Reference: C.N.327.2008.TREATIES-1 (Depositary Notification)

CUSTOMS CONVENTION ON CONTAINERS, 1972

ACCEPTANCE OF AMENDMENTS TO ANNEXES 1 AND 4 OF THE CONVENTION<sup>1</sup>

### Sketch No. 9

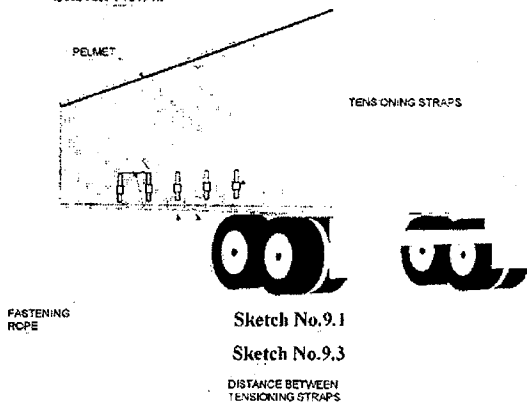
Add the following new sketch to the existing sketches appended to Annex 4, Part I :

- (iii) The sliding sheet guidance and other movable parts shall be assembled in such a way that closed and Customs sealed doors and other movable parts cannot be opened or closed from the outside without leaving obvious traces. The sliding sheet guidance and other movable parts shall be assembled in such a way that it is impossible to gain access to the container without leaving obvious traces. The system is described in sketch No. 9 appended to these Regulations.
